Intersection ID: 19285	Main Street: GLENROCK_DR	Cross Street: NATIONS_FORD_RD	Location:	SW
ADA ID: DCEAF1E668C6	Ramp Type: PerpDiag	Initial Pass/Fail: Fail	Overall Compliance: No	Severity Score: 12.5

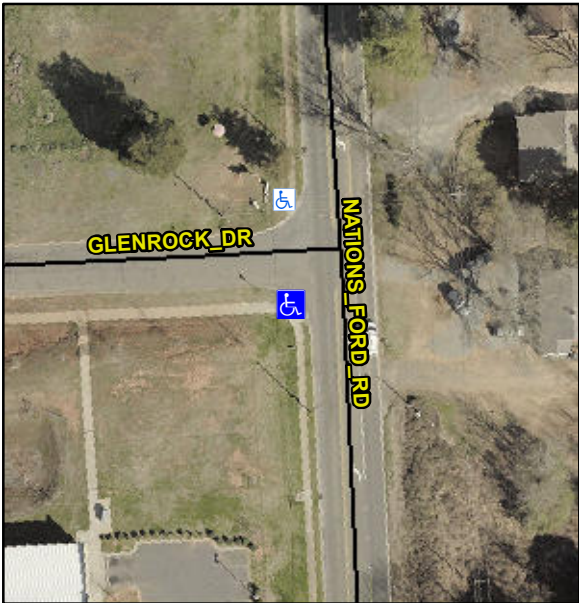
Codes/Mitigation Info/Possible Solution			Field Measurements/Component Compliance					
	Possible Solutions:		Compliance	Description	Data	Compliance	Description	Data
	Remove & Replace Curb Ramp With Two New Directional Ramps or Equivalent.		N/A	Ramp Length (in)	42.0	No	Ramp Slope (%)	9.8
			Yes	Ramp Width (in)	48.0	Yes	Ramp XSlope (%)	1.2
			N/A	Flare Type LT	N/A	N/A	Flare Type RT	N/A
			N/A	Flare Slope LT (%)	N/A	N/A	Flare Slope RT (%)	N/A
			N/A	Flare Traversable LT?	N/A	N/A	Flare Traversable RT?	N/A
	Surveyor Notes:		N/A	Landing Length (in)	N/A	N/A	DWS Provided?	N/A
			N/A	Landing Width (in)	N/A	N/A	DWS Contrast?	N/A
			N/A	Landing Slope (%)	N/A	N/A	DWS Length (in)	N/A
			N/A	Landing X Slope (%)	N/A	N/A	DWS Full Width?	N/A
N/A			Landing Curb? (Y/N)	N/A	N/A	DWS Offset (in)	N/A	
PROW/ADA:		N/A	Shared Landing?	N/A				
R304.2.2		N/A	Gutter Ponding?	N/A	N/A	Gutter Slope (%)	N/A	
		N/A	Gutter Lip Ht (in)	N/A	N/A	Gutter X Slope (%)	N/A

N/A	Painted X Walk1?	No	N/A	Painted X Walk2?	No	
			X Walk 1 Direction	To E		X Walk 2 Direction	To N	
		N/A	X Walk 1 Width (in)	N/A	N/A	X Walk 2 Width (in)	N/A	
			X Walk 1 Slope (%)	4.6		X Walk 2 Slope (%)	1.0	
			X Walk 1 X Slope (%)	0.7		X Walk 2 X Slope (%)	4.2	
		N/A	Ramp inside XWalk1?	N/A	N/A	Ramp inside XWalk2?	N/A	
			Road Slope (%)	0.7	N/A	Clear Space?	N/A	
			Road X Slope (%)	5.5	N/A	Clear Space to XWalk (in)	N/A	
		N/A	Any Obstructions?	N/A	N/A	Storm Grate/Utility Hazard?	N/A	
			Obstruction Type			Storm Grate/Utility Type		
					N/A			N/A
						Yes	Surface Condition? (G/P)	Good
Street 1 Name		NATIONS FORD RD						
Stop Condition-Street 2		None						
Street 2 Name		GLENROCK DR						
Stop Condition-Street 1		StopSign						
Total Cost:		\$ 3200.00
